**Re: Compark Village South F1 AMD 2 - Multifamily
Chambers Road and Belford Avenue
Case/AP#: SP21-118**

Merrick & Company has reviewed the comments dated December 2, 2021, regarding the Compark Village South development. The following summarizes Merrick's responses to the comments provided by the Town of Park Development Review Division.

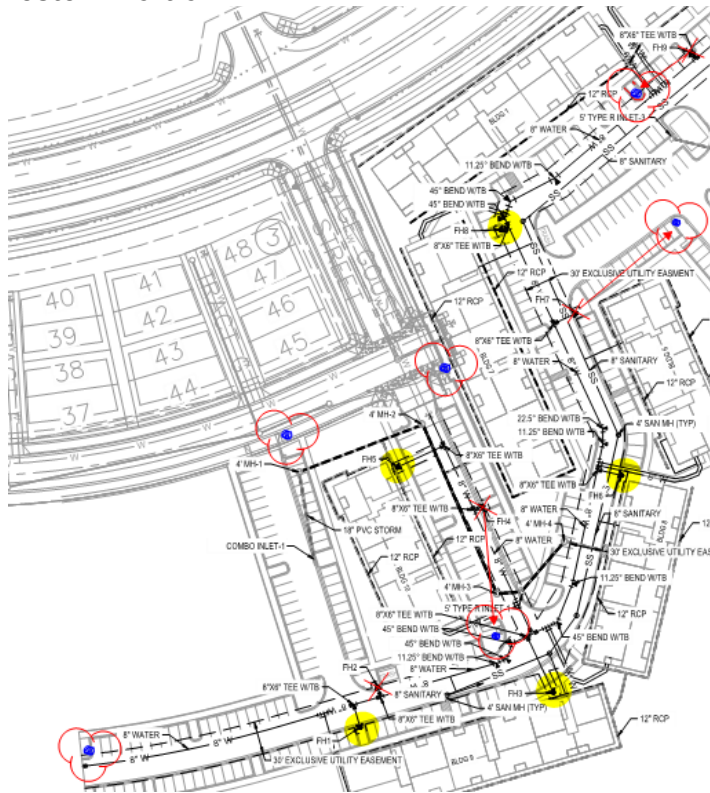
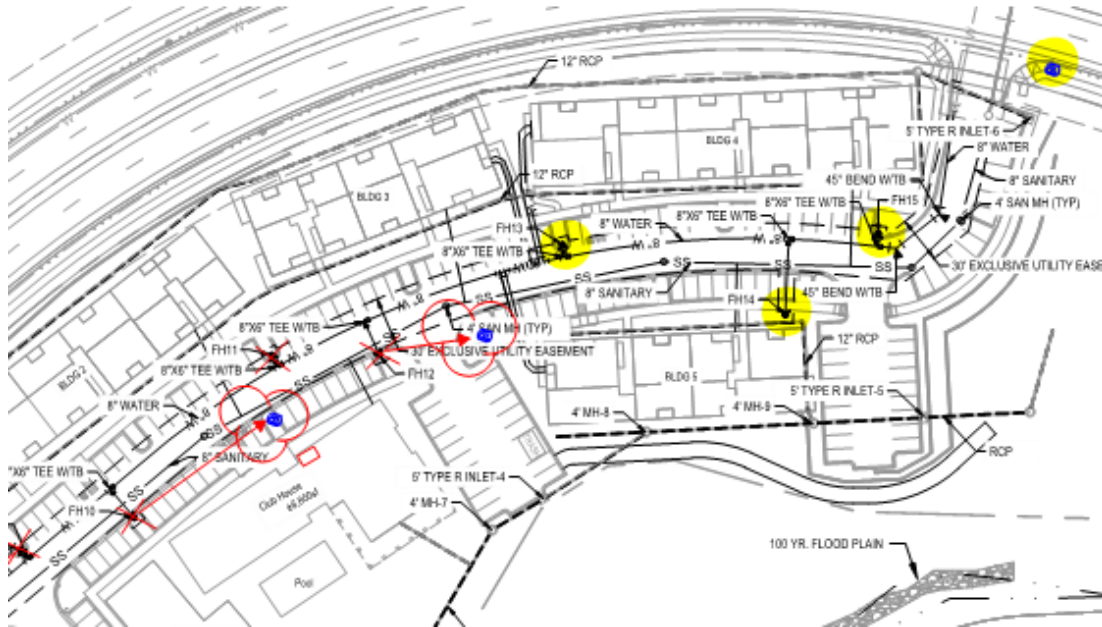
13. The hydrant distribution has been redlined to accommodate response more effectively; the overall utility drawing shall include the hydrant distribution for all filings and the following criteria.

See below for information on hydrant location criteria and on revisions to the hydrant layout (hydrants have been deleted, added, and relocated while shown at entry ways if not currently addressed):

- Hydrants shall be located no further than 40 feet of the building to be served.
- Hydrants serving buildings with fire suppression systems shall be located in the general area of the riser room.
- Divided roadways require that hydrants be spaced at 250-foot intervals on a stagger (on each side of the road); these hydrants shall be located 500 feet apart on each respective side of the road.
- Hydrants shall be located at the entry into each sub area.
- Hydrants shall be located at the end of most cul-de-sacs.
- Hydrants shall be located at the corners of all streets where possible
- Hydrant spacing shall meet the requirements of the 2018 IFC Chapter 5 and appendix B and C

Response: Hydrants have been relocated per the provided markups.
